RECEIPT DATE: 2/28/18 **ONSITE SEWAGE DISPOSAL SYSTEM**

PROPERTY ADDRESS: 15320 Galaxy Drive

SUBDIVISION: Fairlane Farms

**RE: OSDS Plan
15320 Galaxy Drive**

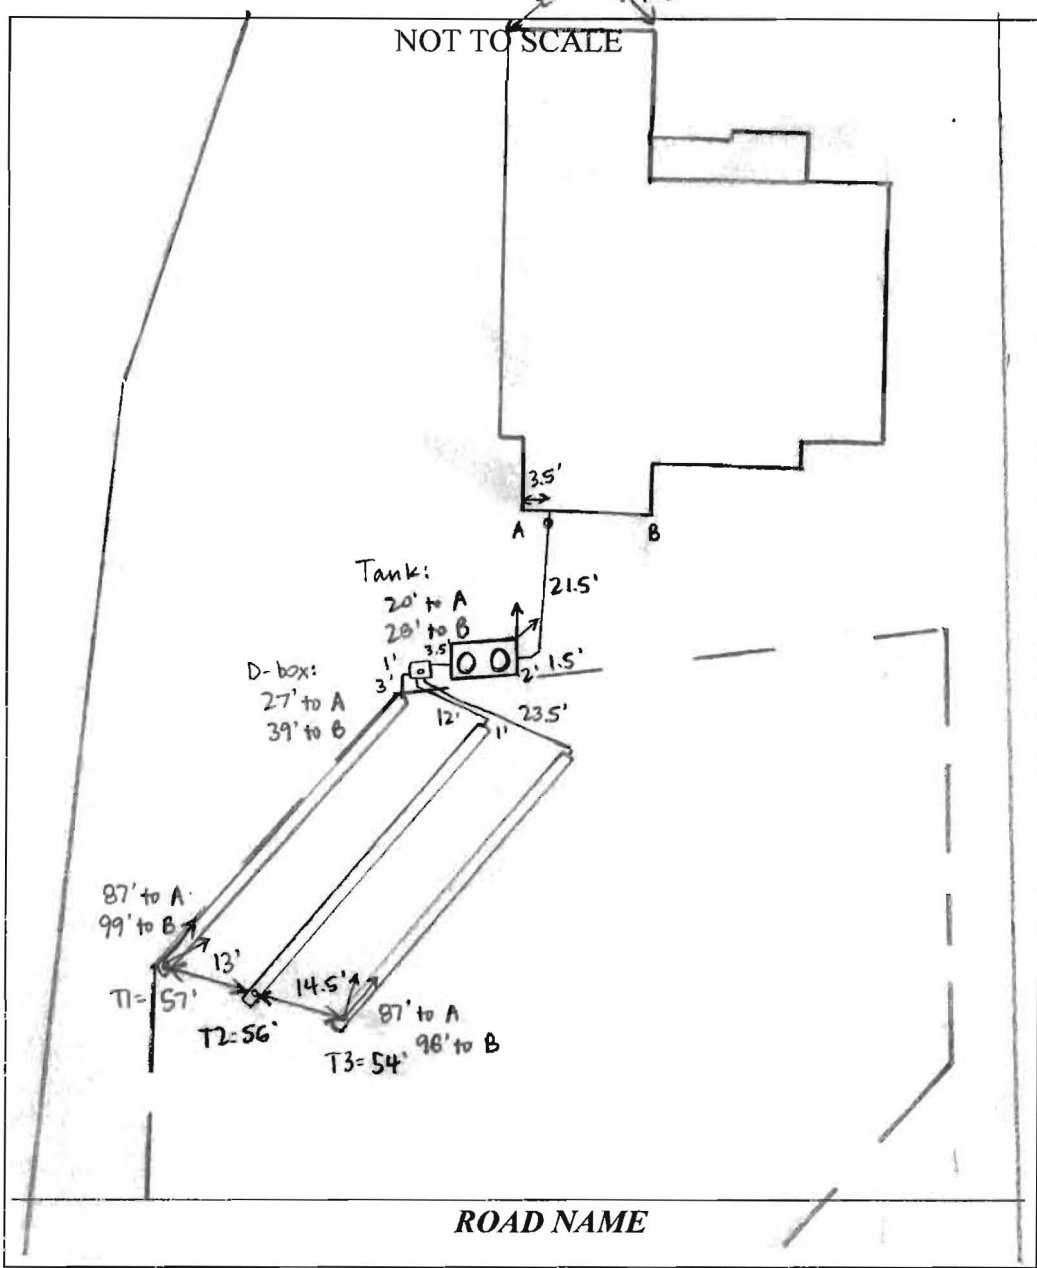
3/15/18 Met S. Carroll on site for layout. SDA corners staked. Shot contour - laid out 3 x 56' trenches to use upper SDA corner. Pipe under footer exposed - will not make fall to tank w/ 4' cover. Also will not make 4' inlet @ trench 1. Pipe comes out 43" below basement floor, plan shows 32.8" below. (SC) 4/23/18 Pipe raised 1' at foundation. Shot elevations - will make 4' inlet @ trench 1. Shot contour + laid out 3 x 56' trenches. (SC)

4/26/18 House connection made, tank set. S. Carroll adding stone to T3 - 3' wide, 4' inlet, 8' bottom. (SC) 4/26/18 S. Carroll just finished digging T2 bottom @ 6.5'. Backfilled most of trench + dug to 8'. Using laser to check depths. [corrective action + completed]. (SC) 4/27/18 T1 complete + left open for inspection. 3' wide, 3.5' to stone. D-box installed - connected to tank + trenches. Levelled speed levelers in D-box. (SC)

SEPTIC SYSTEM
INSTALLATION SITE PLAN

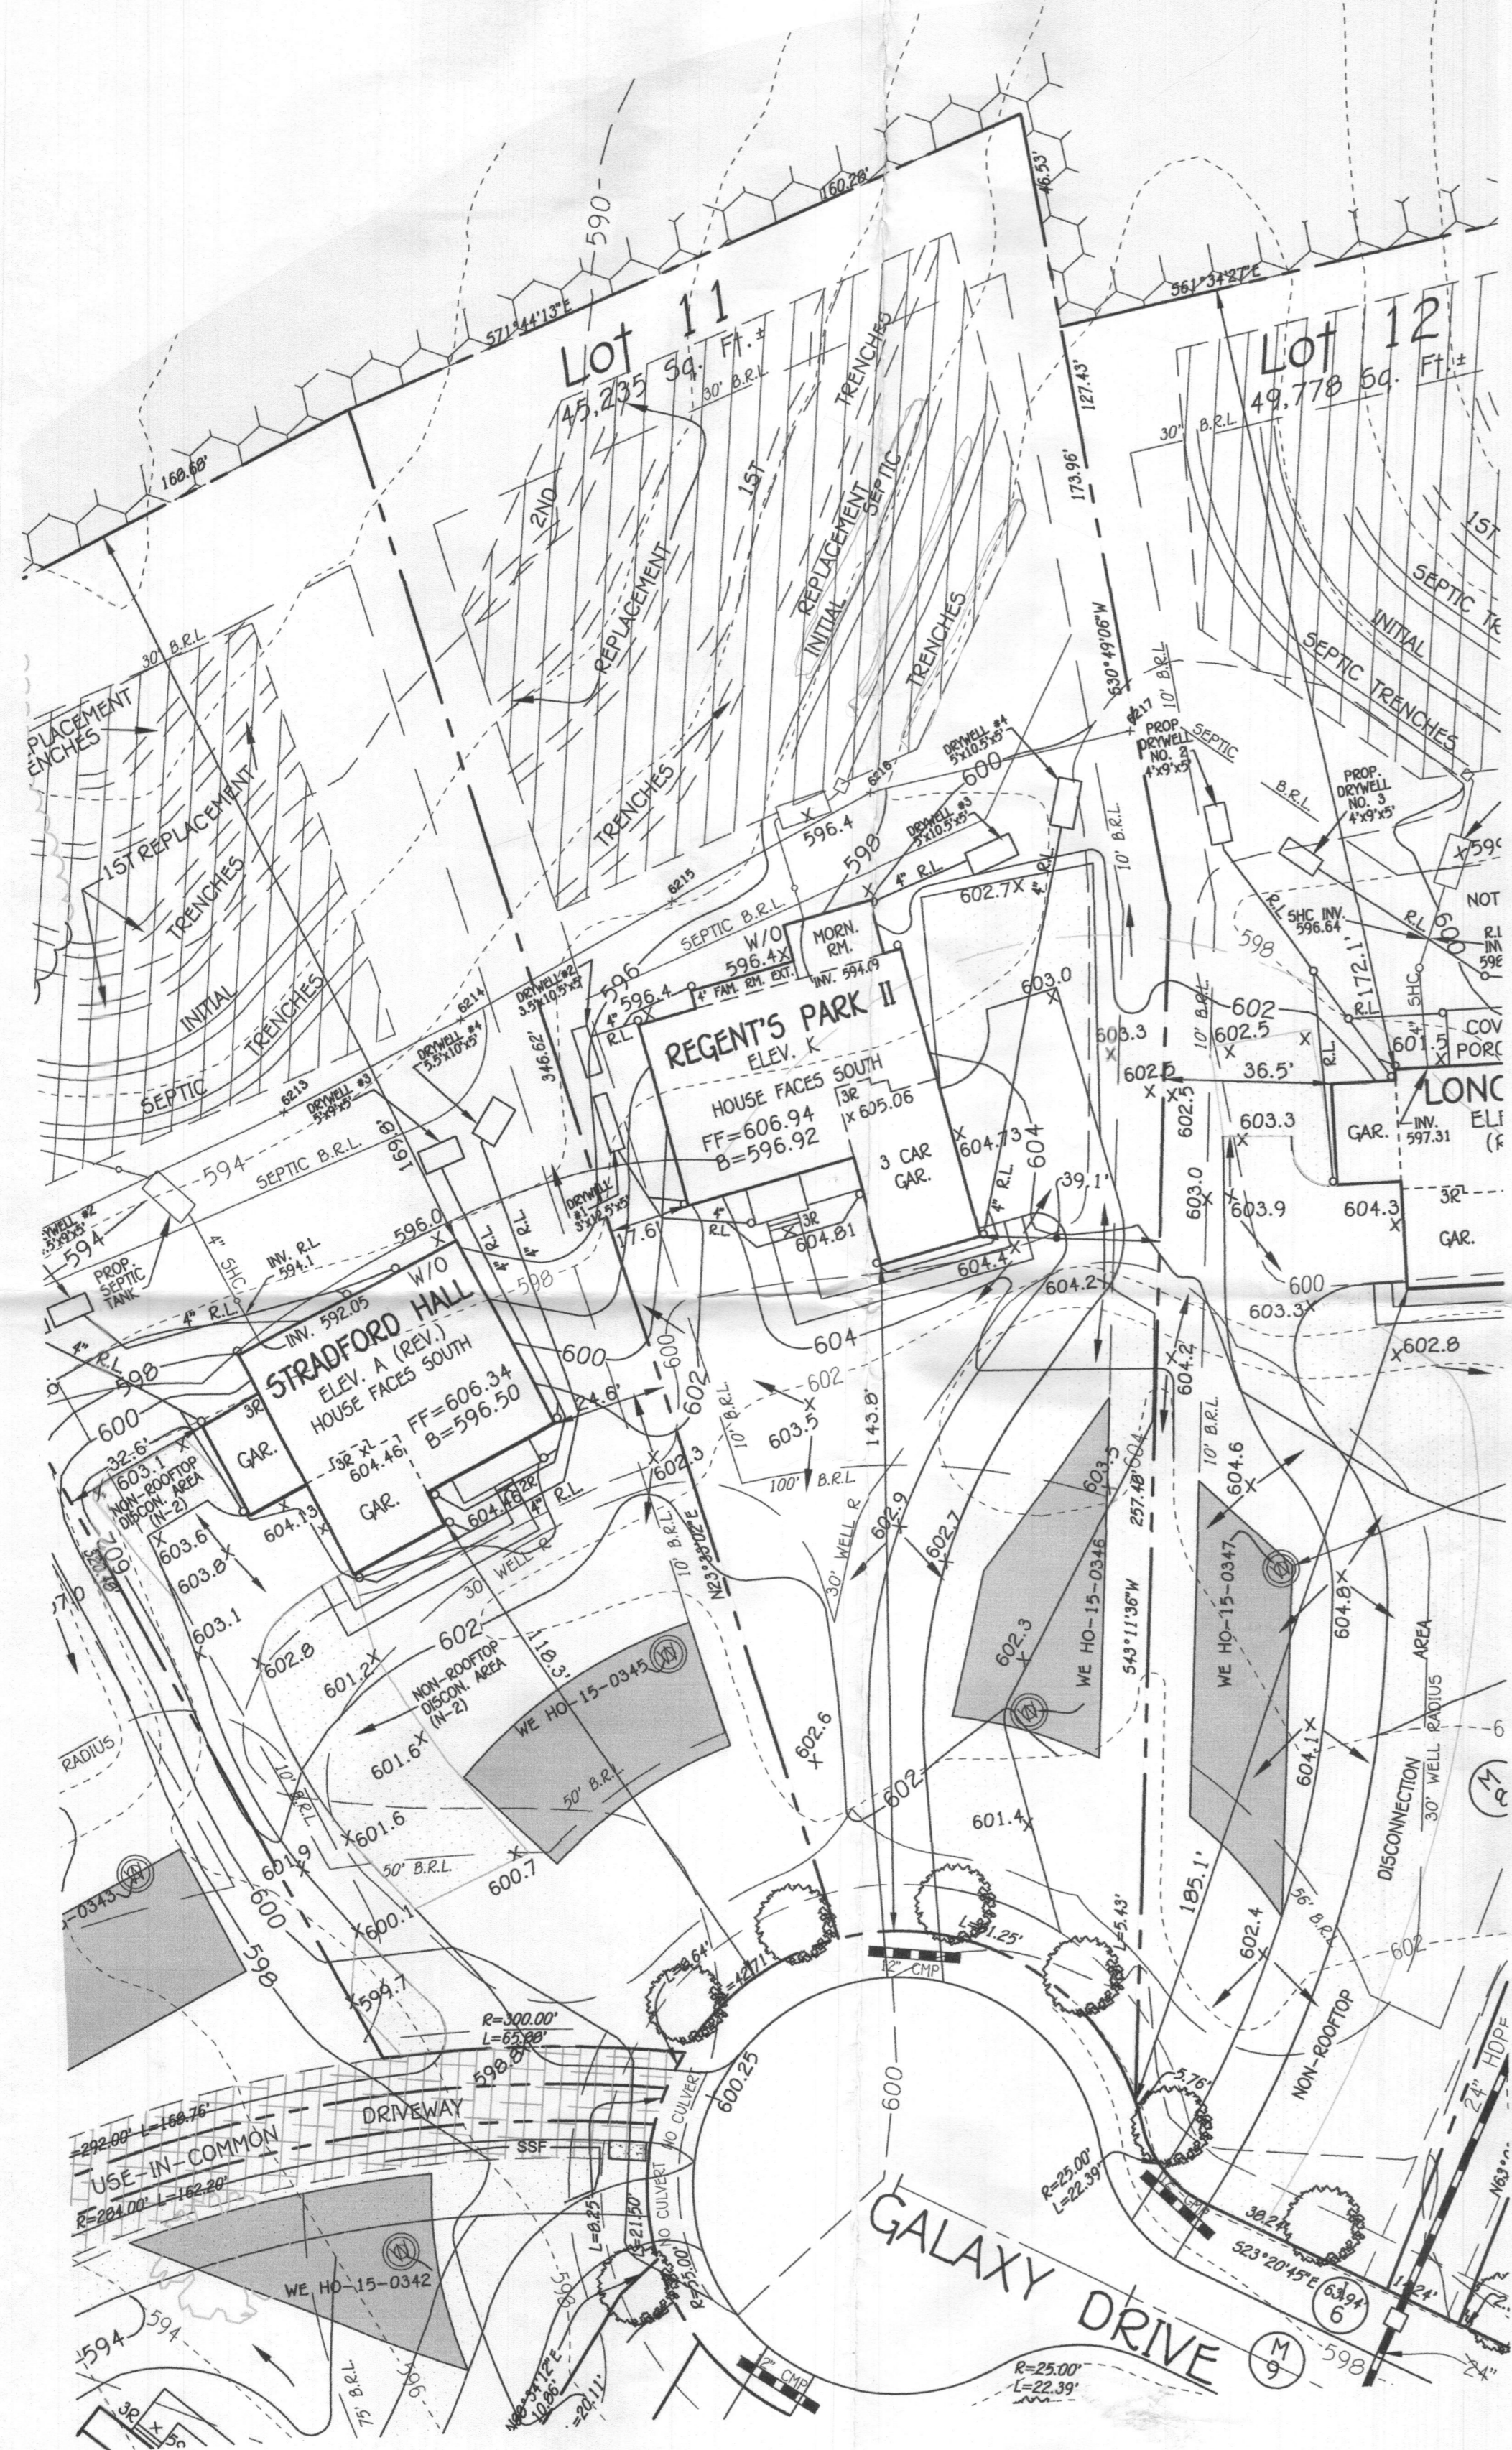
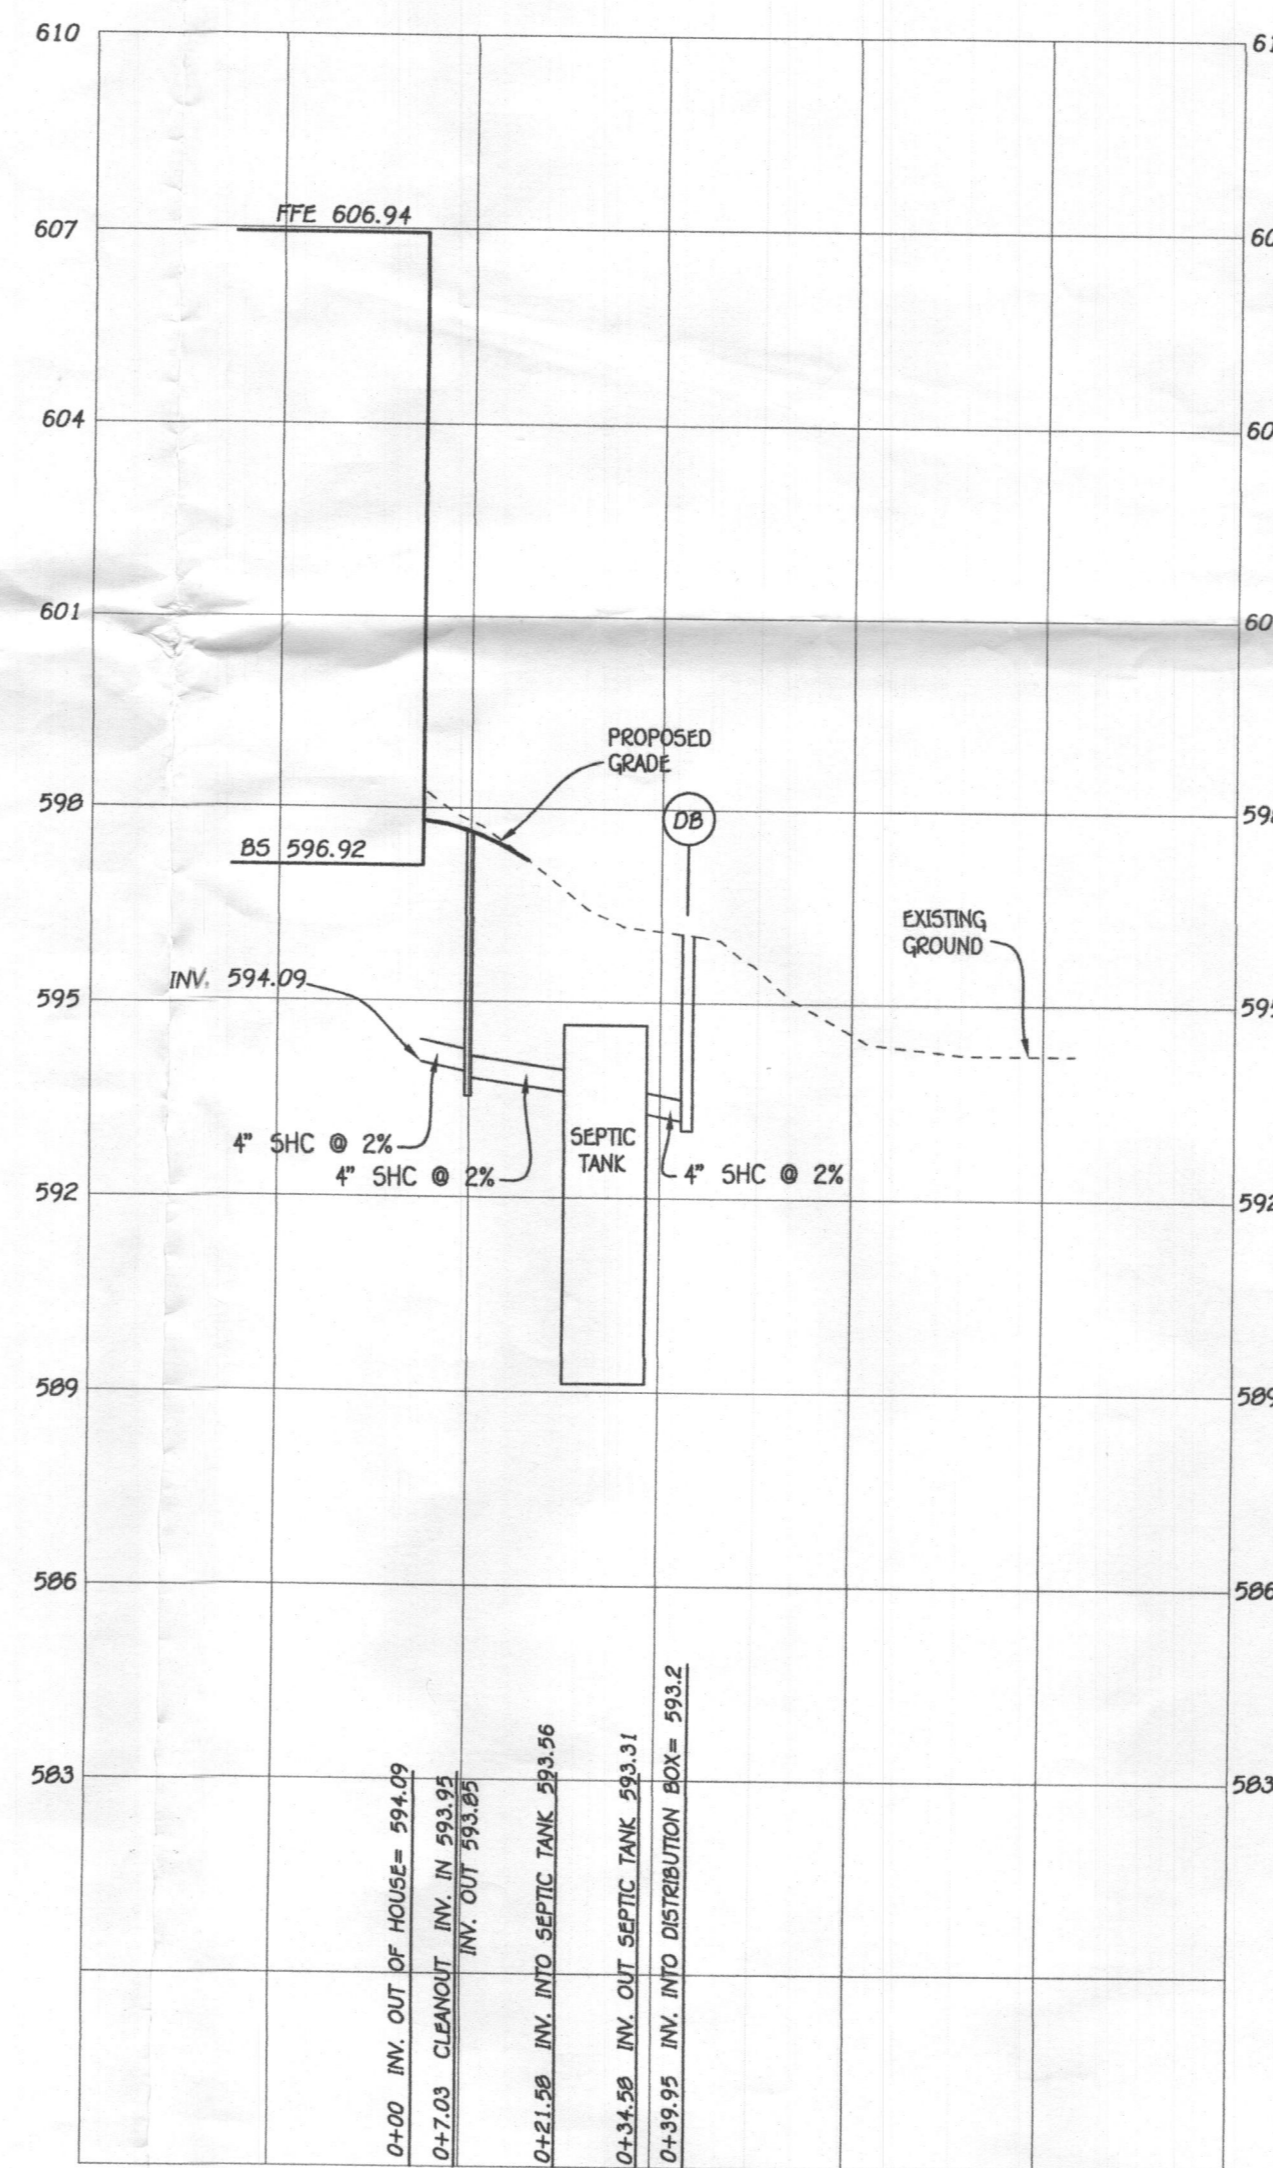
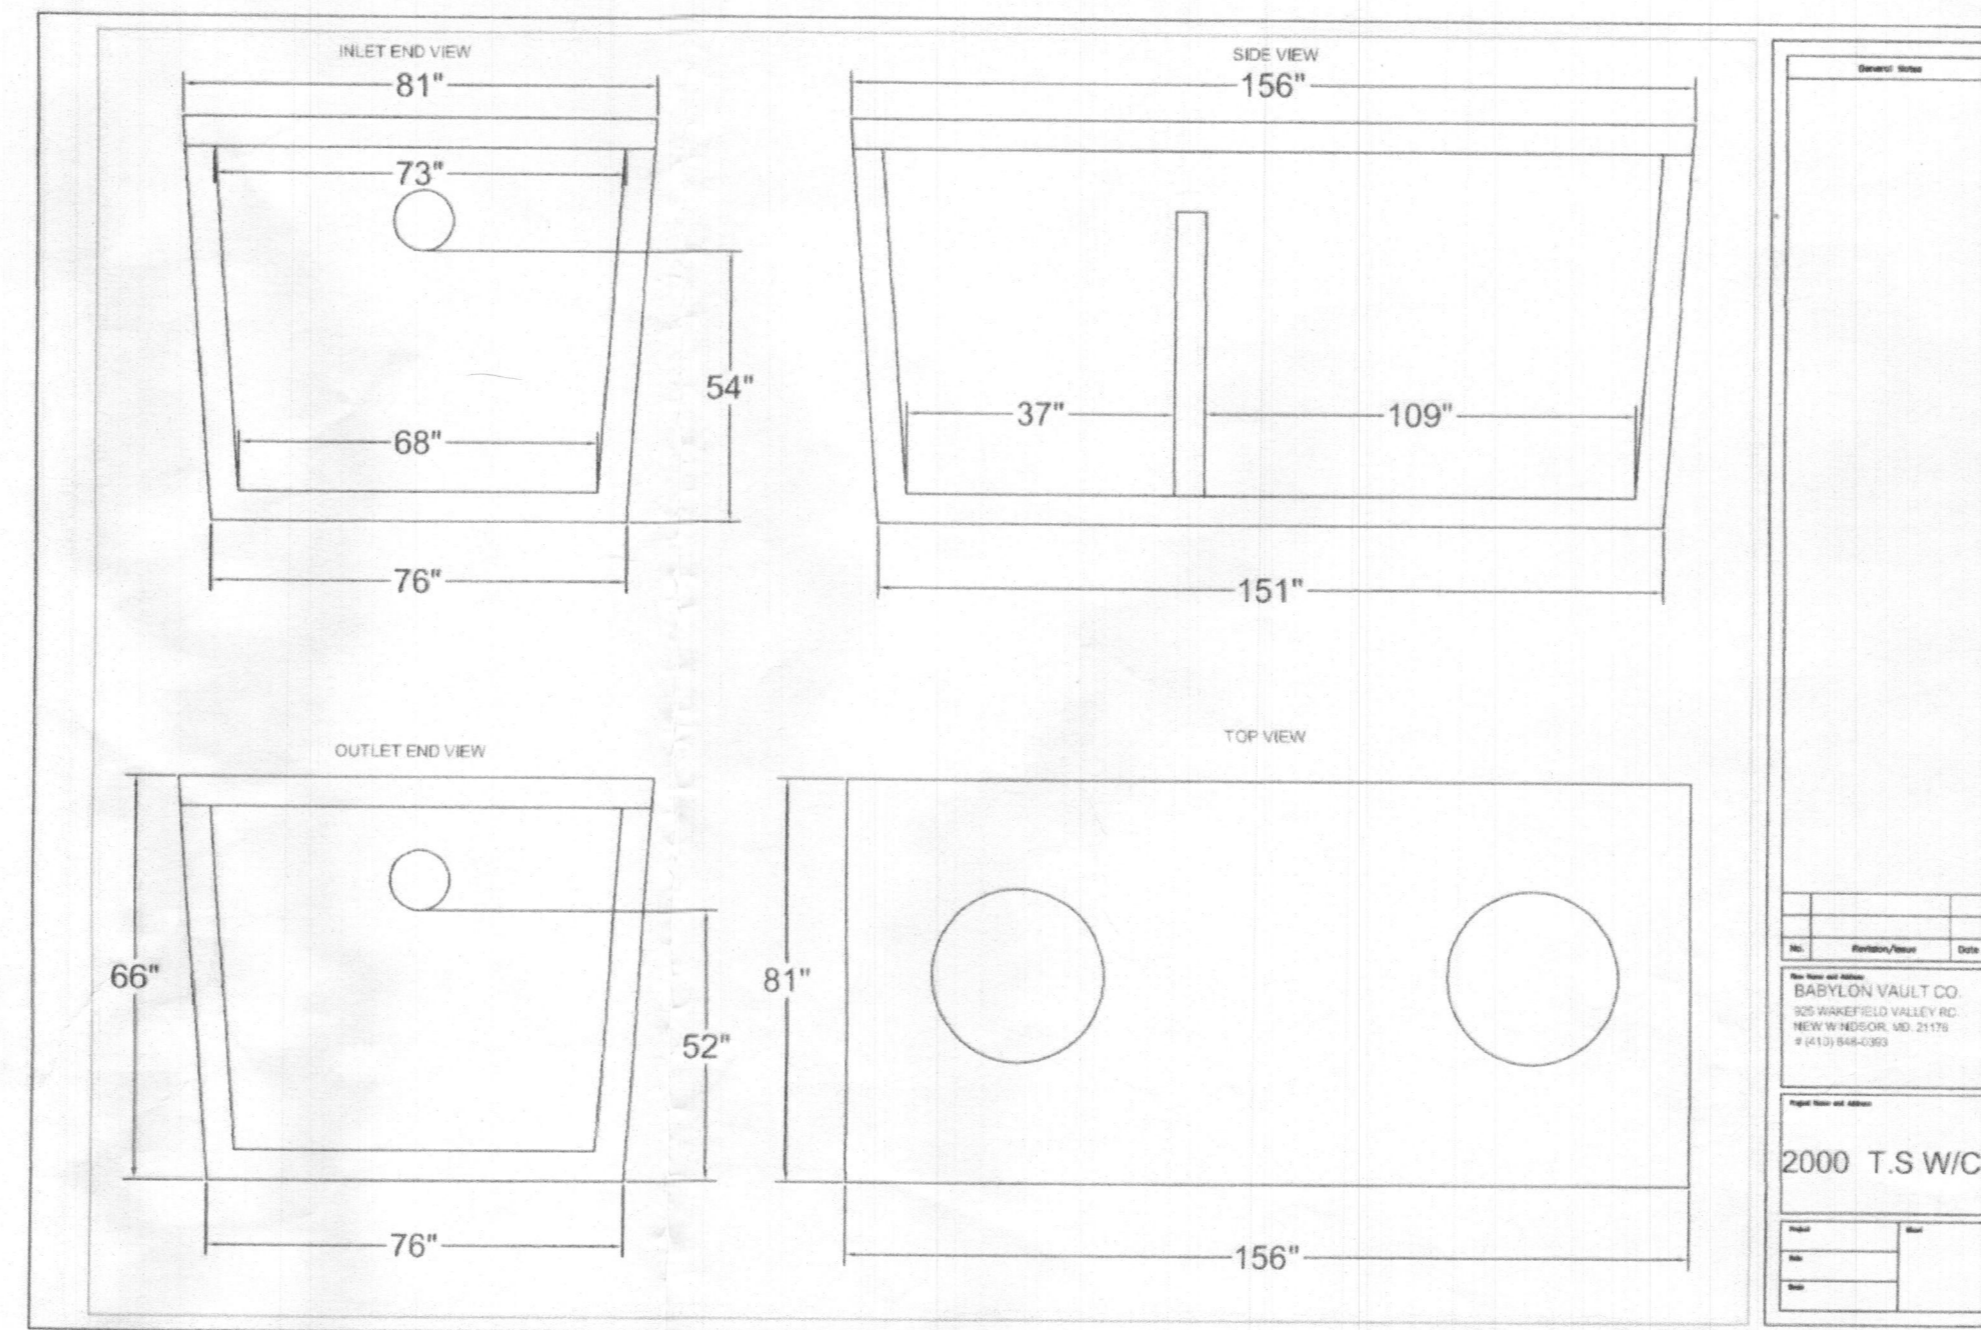
The floor plan for 5320 Galaxy Drive shows 6 bedrooms (1 B.R./Home Office in the basement and 5 B.R. on the second floor) but the septic plan is only sized for 5 bedrooms. In addition, the building permit site plan shows the morning room within 20 feet of the septic tank (the setback is at least 20 feet). Please revise the floor plans or the septic plan and BP site plan accordingly.

- 1.) The septic tank does not meet the 20 foot setback to residence.
- 2.) The sidewall credit for initial system should be 0.625 (not 0.556) in your calculation. However, you could use up to 3.5 feet of sidewall credit reducing the required length of trench (See attached septic specs)
- 3.) Application rate for 1st replacement system should be 0.8 (not 0.6)
- 4.) Application rate for 2nd replacement system should be 0.6 (not 0.8)
- 5.) Align trench data with trench detail. The difference between grade and bottom of trench should be 8 ft. (not 7.9 ft.).
- 6.) Match septic profile BSE (597.10) with BSE on plan (596.92).
- 7.) Trench Depth for initial and replacement system should be 8 feet (not 7 and 7.5 respectively) in calculations.

- 1.) Initial system sidewall credit calculation has a 2 in it but should be a 3.5. Otherwise 0.45 is still correct.
- 2.) First system calculation is not utilizing entire sidewall credit of 3.5 feet. It is not mandatory but it would reduce required trench length to approx. 141 feet.
- 3.) Show space between d-box and initial trench on plan. In general, label trenches a little better. Please be sure that trench lengths on plan match calculated lengths.
- 4.) Define 2nd replacement trenches and label (i.e. show 4 separate trenches)
- 5.) Make septic tank 20 feet from house.
